CITY OF FRESNO
DEVELOPMENT AND RESOURCE MANAGEMENT DEPARTMENT
CONDITIONS OF APPROVAL

PLAN AMENDMENT APPLICATION NO. A-17-011
REZONE APPLICATION NO. R-17-016
DEVELOPMENT PERMIT APPLICATION NO. D-17-128

160 West Nees Avenue

SITE PLAN REVIEW
LES SCHWAB TIRE CENTERS
NEC GLENN AND NEES AVENUES
FRESNO, CA

SITE PLAN	
Project No.	LST100943.02
Drawn By:	BM
Checked By:	TJM
Date:	8/01/2017

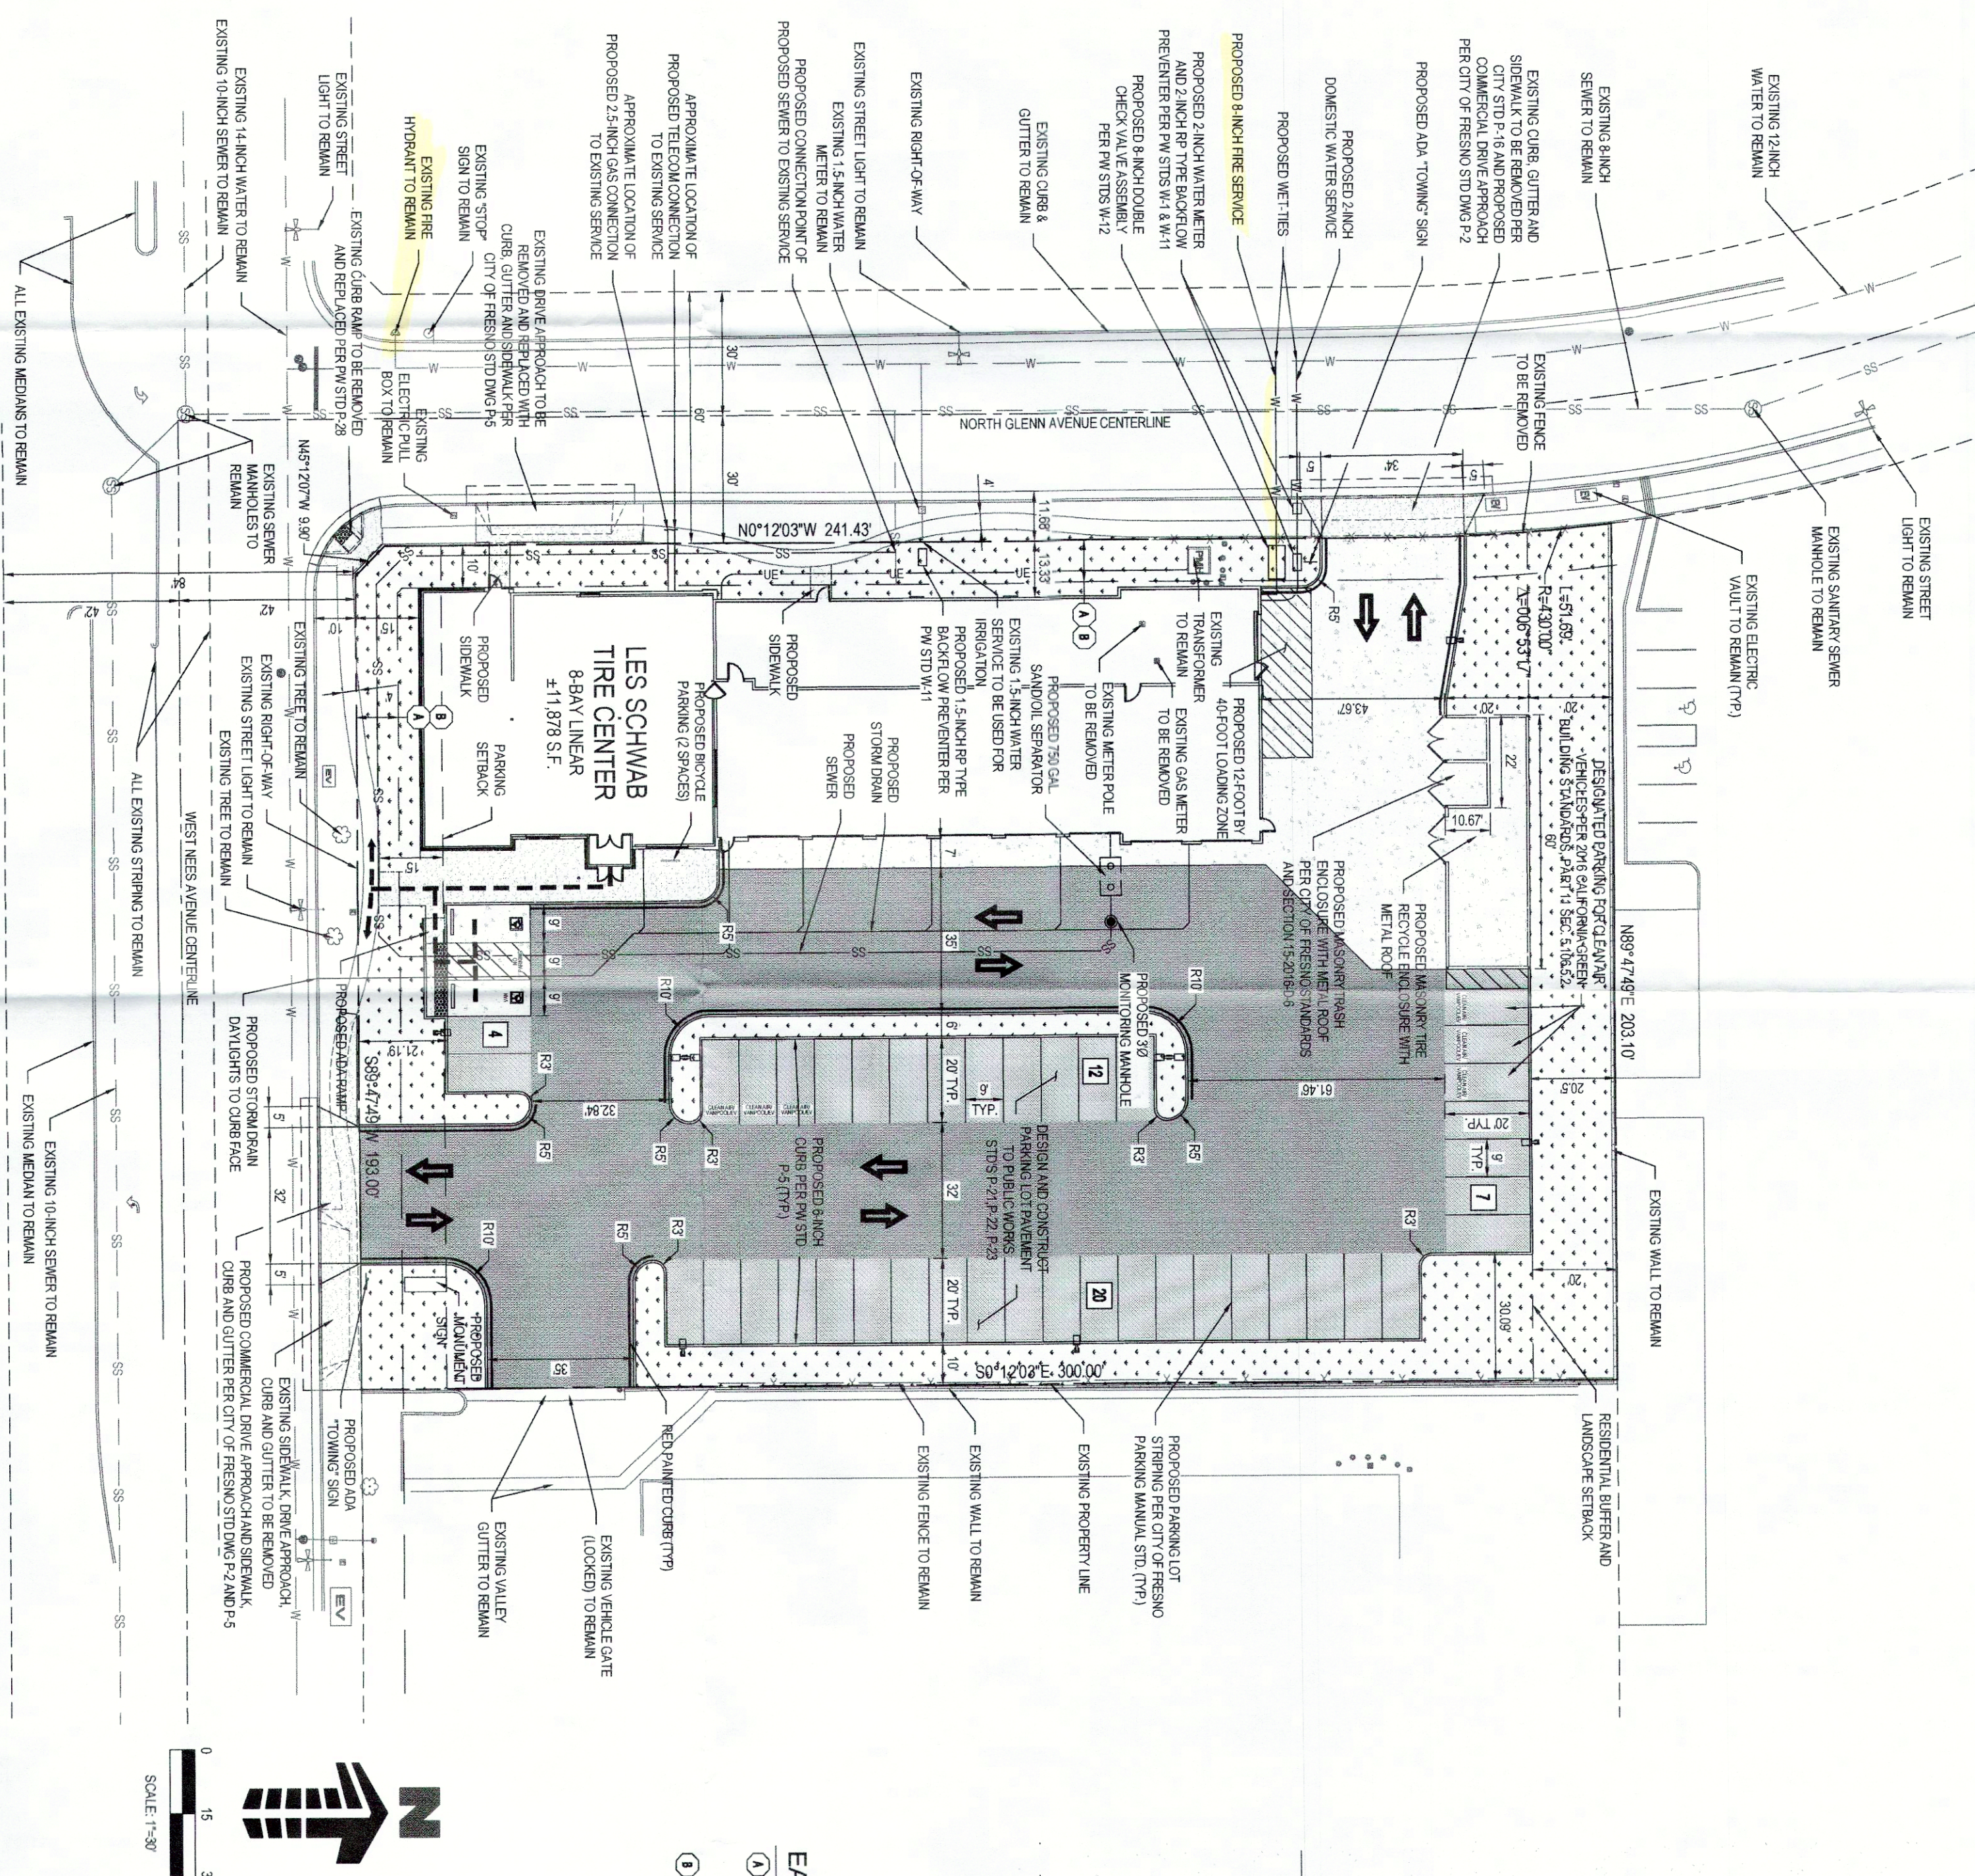
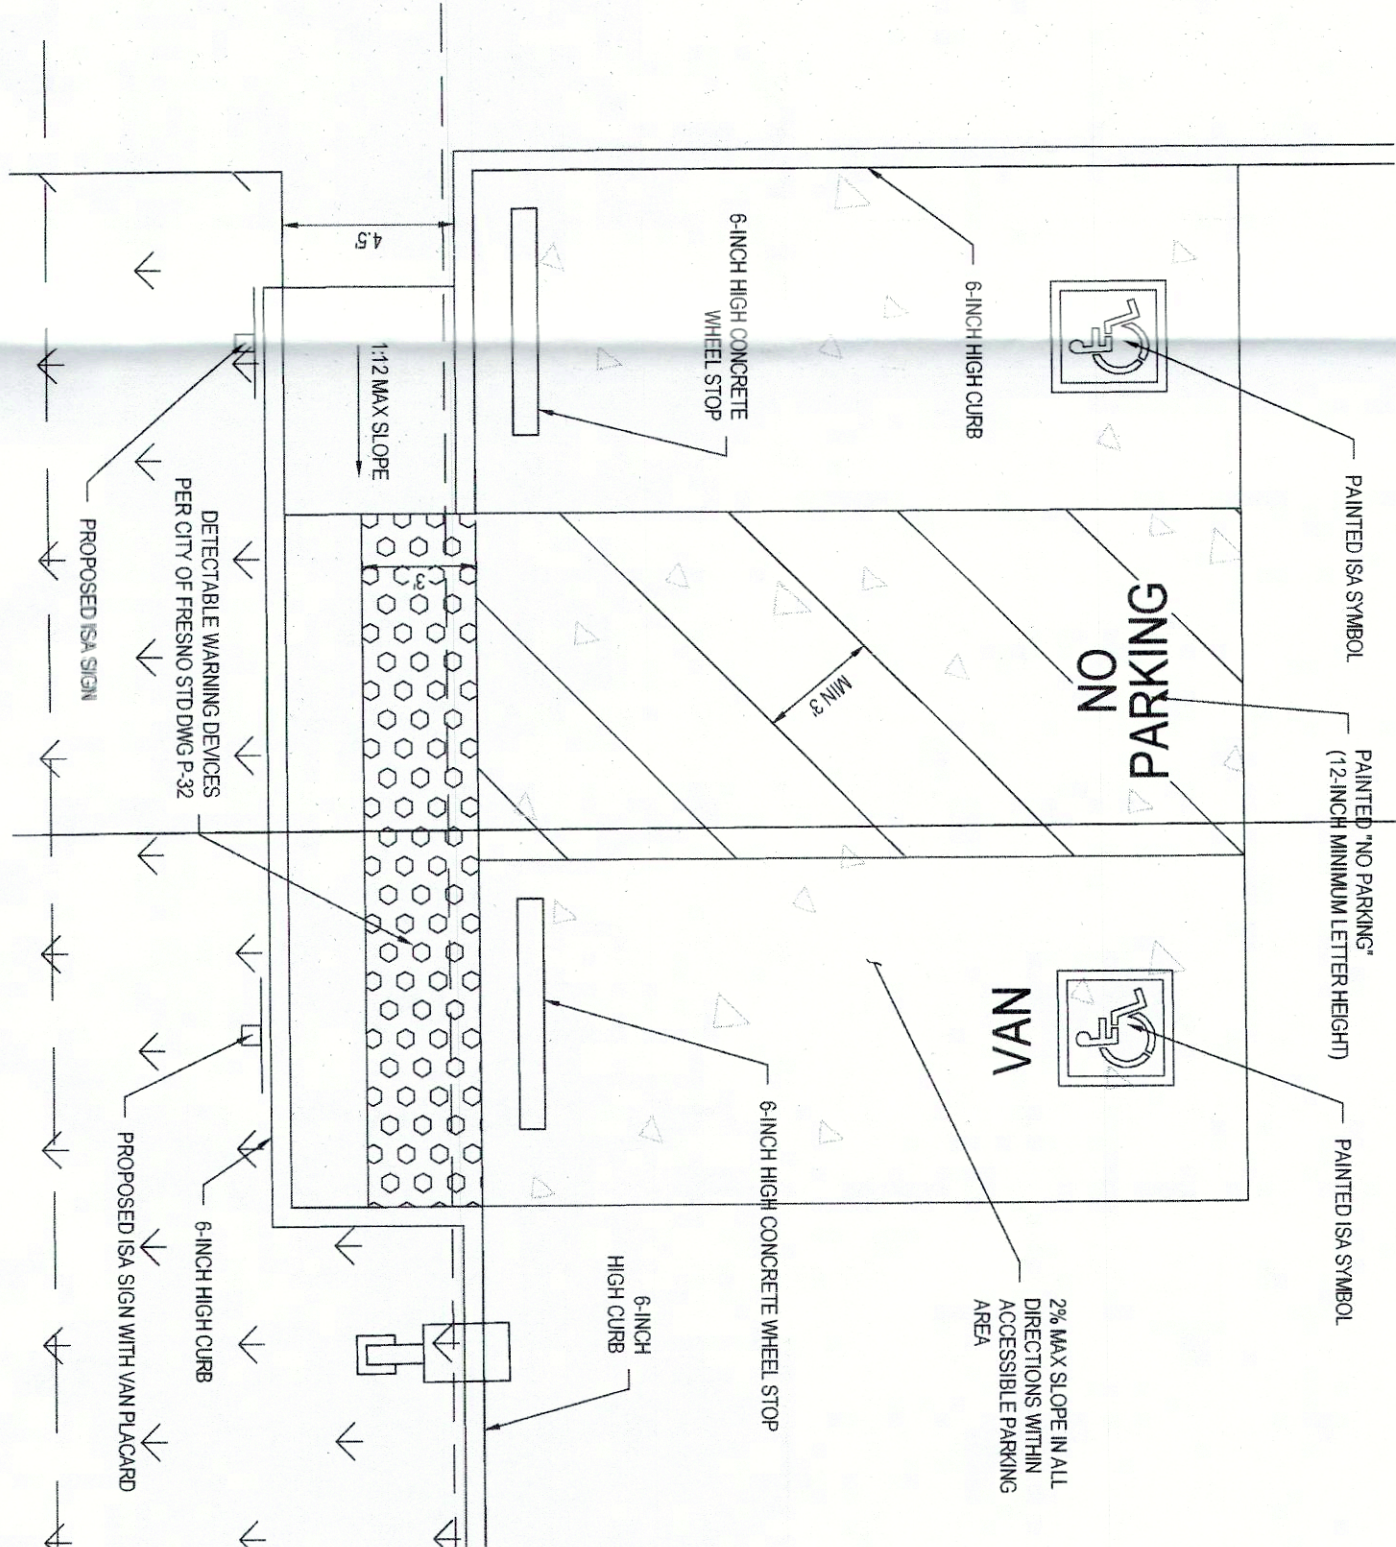
Show the proposed location of fire sprinkler riser and FDC. Note: Interior sprinkler risers not located within five feet of an exterior door require an exterior wall mounted indicating control valve. FFD policy section 405.025 and 405.003.

Show the location of the fire department connection. Fire department connections shall not be installed within five feet (5') of any building opening, excluding a fire department riser access door. (FFD Development Policy 405.025)

Note on plan: The minimum size of all fire department connections shall be based upon the system type. No connection shall be less than 2 ½" in size. (FFD Development Policy 405.025)

Fire department connections shall be located on the street side of buildings, fully visible and recognizable from the street or nearest point of fire department vehicle access or as otherwise approved by the fire chief. 2016 CFC, Section 912.2.1.

Note on plan: Provide an exterior Knox box on the ground floor adjacent the main entrance at a height of 6 feet from grade. Knox boxes shall be provided for buildings where any of the following conditions exist: high-rise building, interior elevator (s), fire sprinkler system with interior riser(s), fire pump rooms, fire alarm system, unduly difficult access, and/or where required by the Fire Marshal (or designee). Keys placed in the Knox box shall be identified with a tag or label. Knox box applications can be obtained at the Fresno Fire Department, 911 H Street Fresno, CA 93721.
